MAINE TURNPIKE AUTHORITY

ADDENDUM NO. 1

CONTRACT 2019.09

BRIDGE IMPROVEMENTS
MAINE CENTRAL RAILROAD OVERPASS
MILE 47.9

SHEET NUMBER: GP-02
 26 OF 116

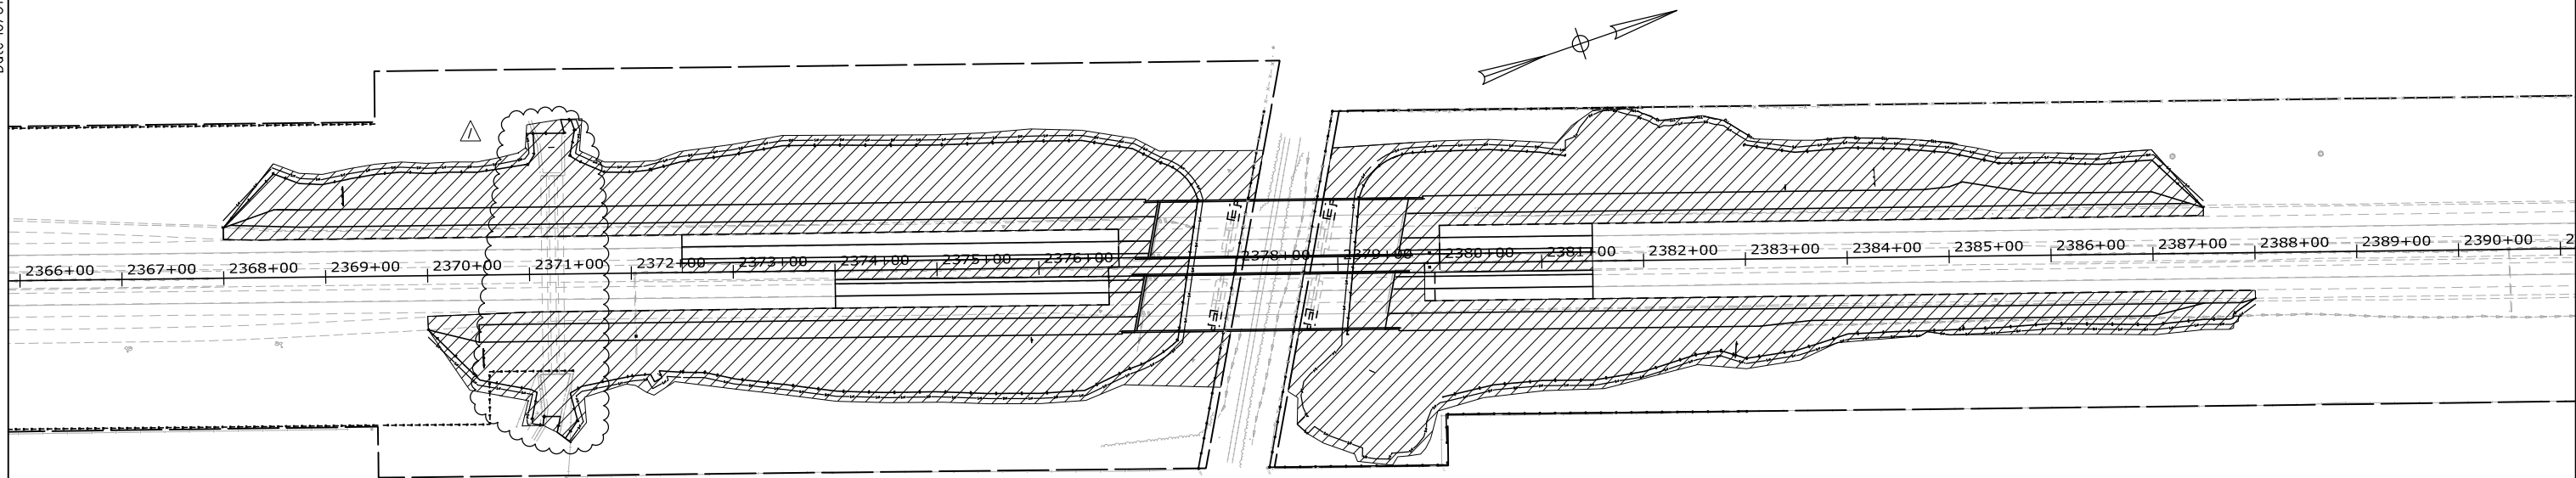
6. MAINE CENTRAL RAILROAD PART II, Plan Sheet GP-02, sheet 26 of 116 “General Plan 2”: This plan sheet is removed in its entirety and replaced with the attached revised sheet 26.

SHEET NUMBER: XS-04

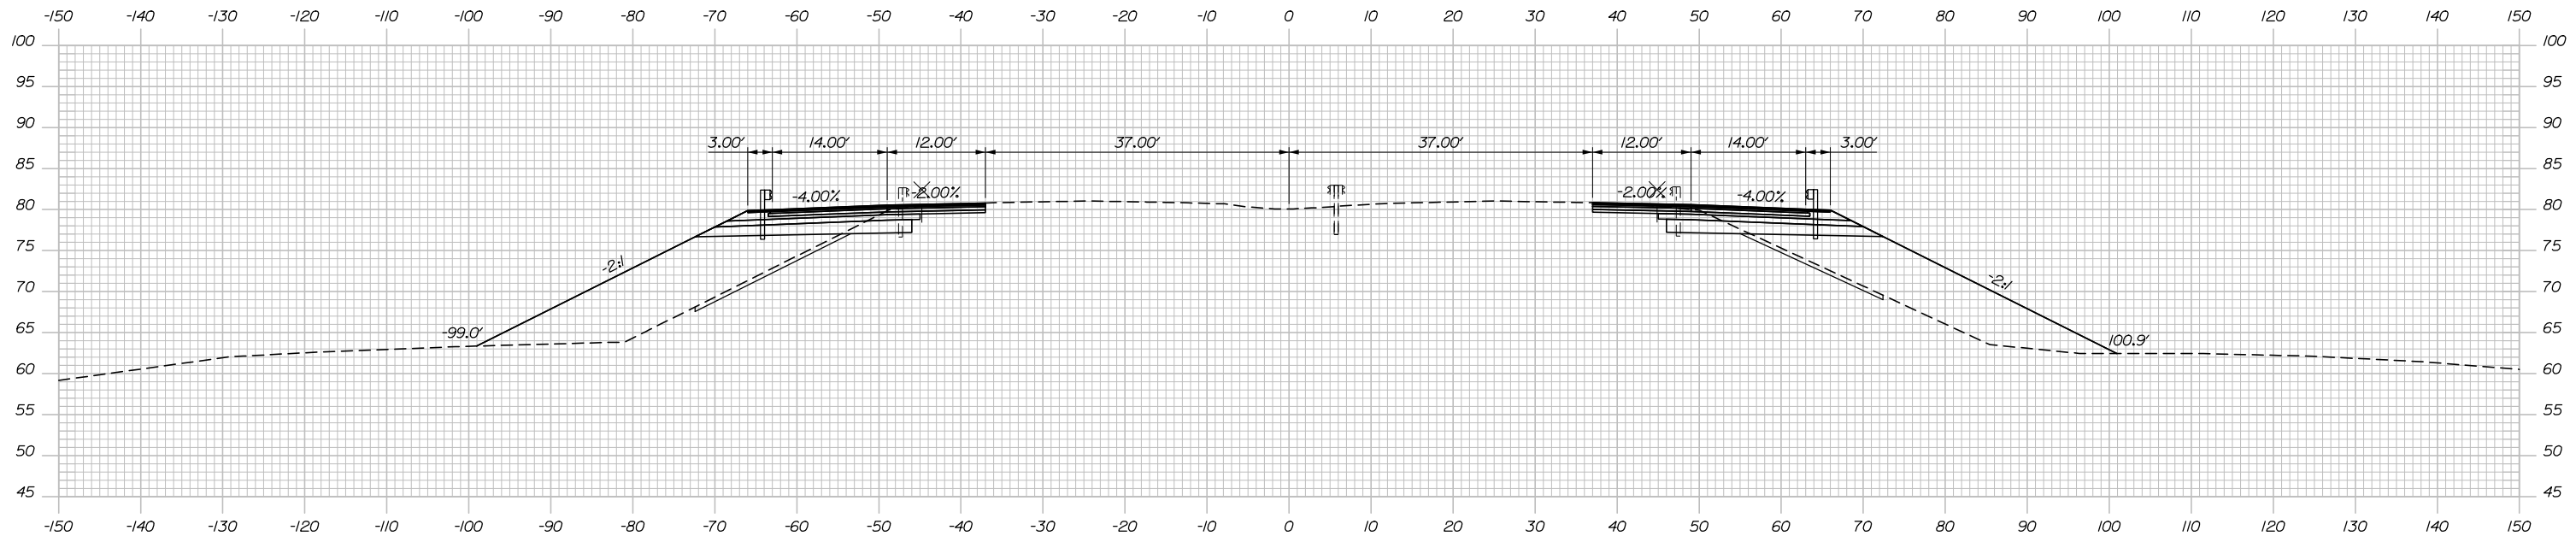
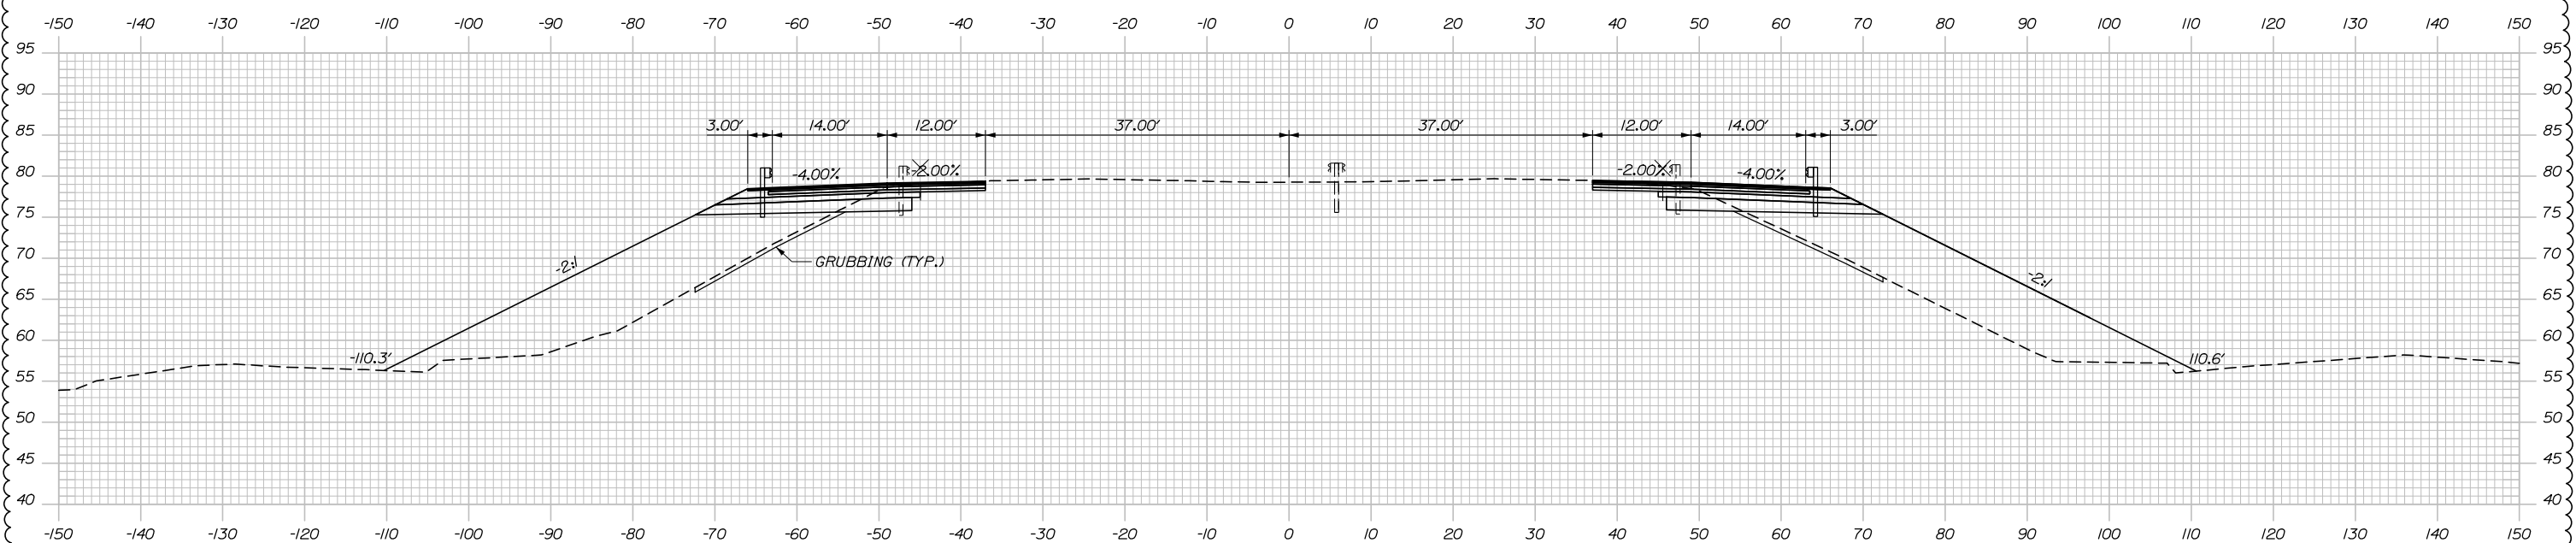
8. MAINE CENTRAL RAILROAD PART II, Plan Sheets XS-04 and XS-05, sheets 36 and 37 of 116 “Cross Sections”: These plan sheets are removed in their entirety and replaced with the attached revised sheet 36 and 37.

SHEET NUMBER: S-40
CONTRACT: 2019.09
91 OF 116

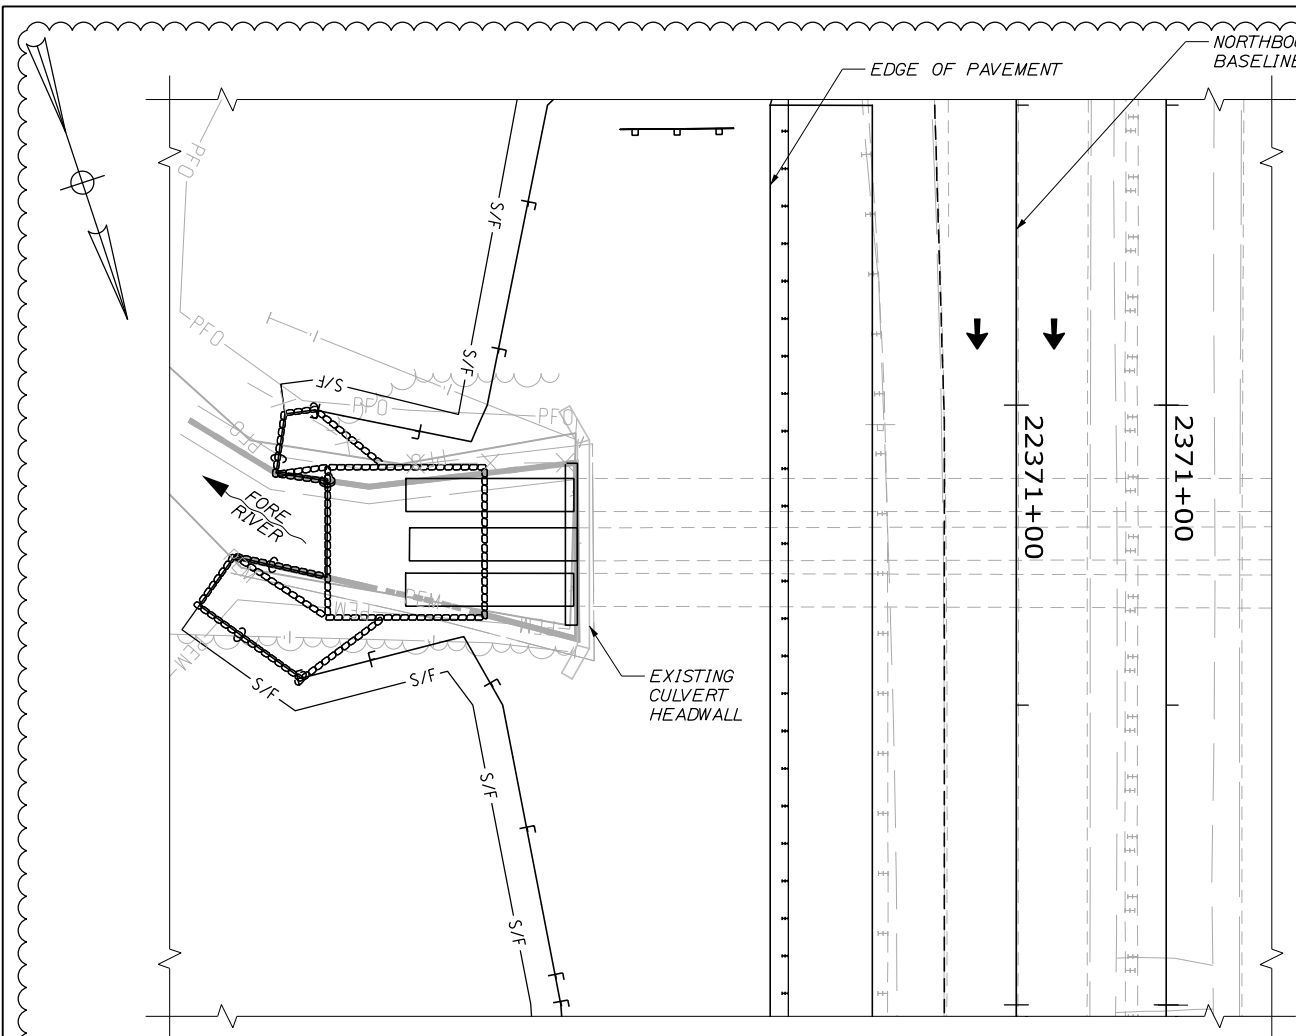
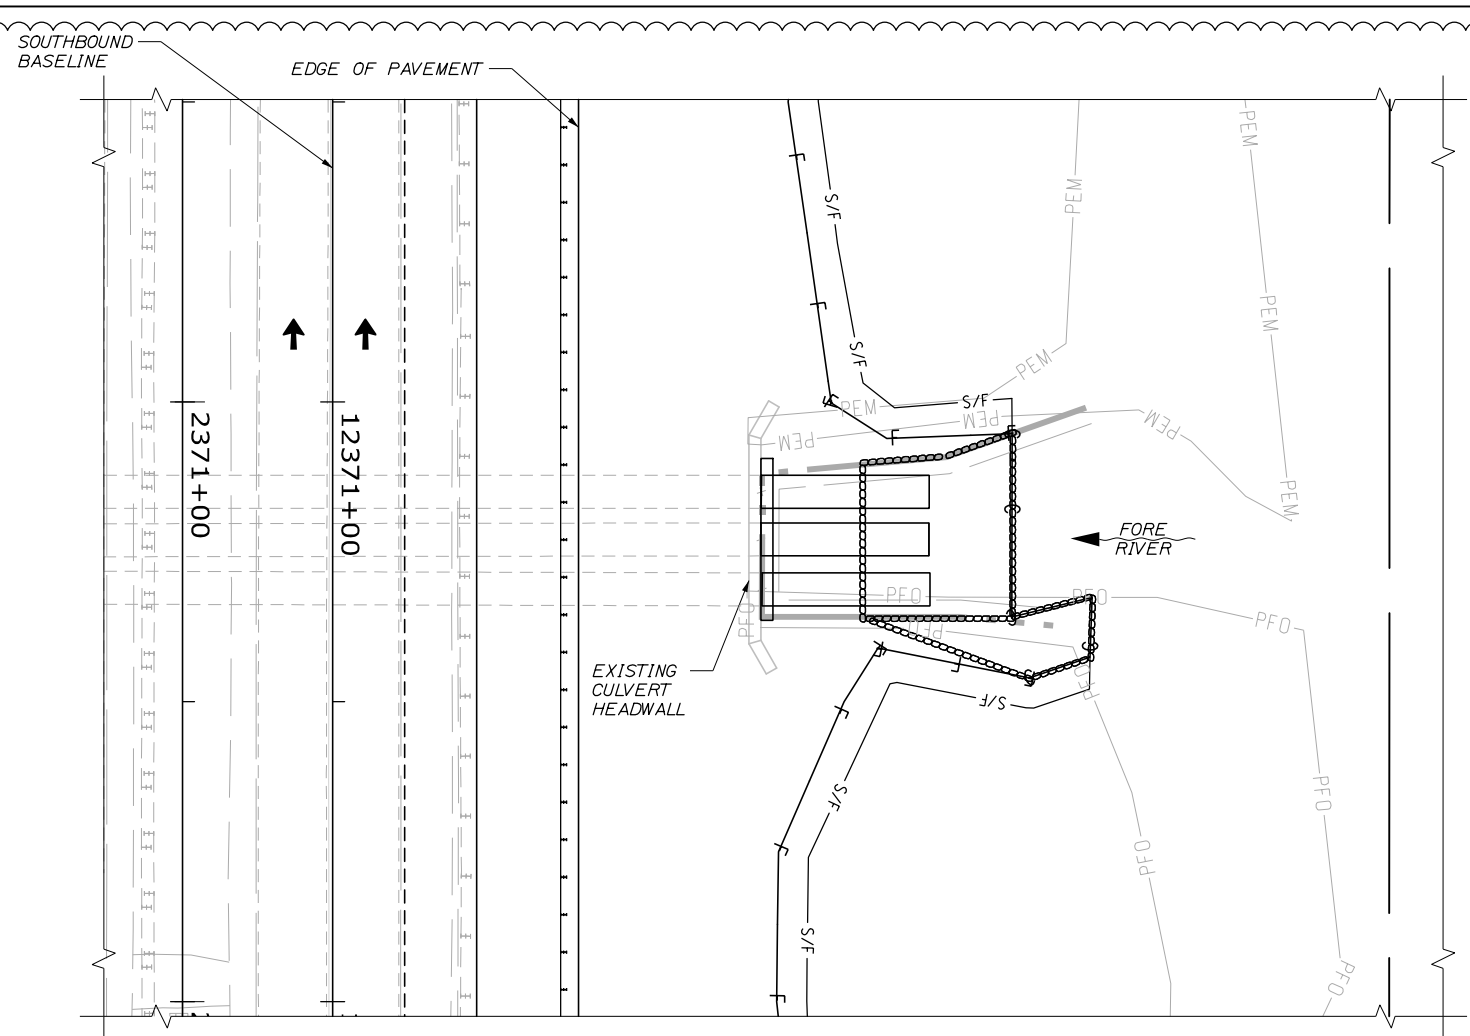
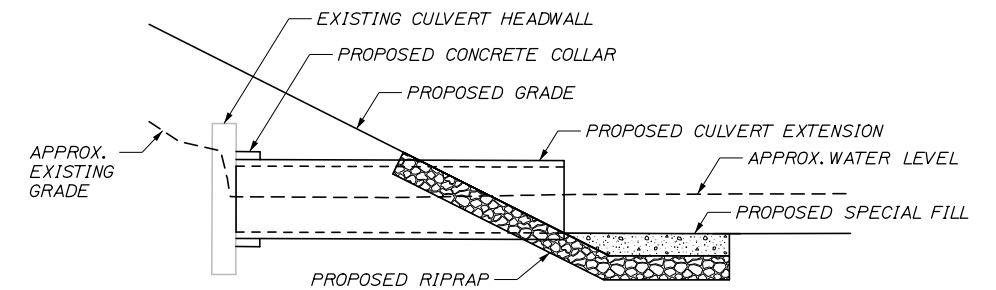
9. MAINE CENTRAL RAILROAD PART II, Plan Sheet S-01, sheet 52 of 116 “General Notes, Index, Quantities”: This plan sheet is removed in its entirety and replaced with the attached revised sheet 52.
10. MAINE CENTRAL RAILROAD PART II, Plan Sheets S-40 through S-42, sheets 91 through 93 of 116 “Fore River Culvert I through III”: These plan sheets are removed in their entirety and replaced with the attached revised sheet 91 through 93.

Answer: The sheet pile wall shown on the Plans is deleted. In lieu of installing a sheet pile wall system the Contractor shall extend the existing Fore River culverts as shown on the revised plan sheets. Note that this work will not be allowed to occur until after approved permits are received from MaineDEP and the U.S. Army Corps of Engineers. These permits are expected to be received on or before July 2019. Additionally, all work related to the culvert extensions shall be completed during the designated in-stream work windows defined in Special Provision 107.4.6, Prosecution of Work.

This work also consists of furnishing and installing a concrete collar to join the existing Fore River Culvert concrete headwall to the proposed pipe extensions in accordance with the details as shown on the Plans. The Contractor shall note that the concrete headwall and existing pipe ends may be of different sizes and may not fit snugly together.
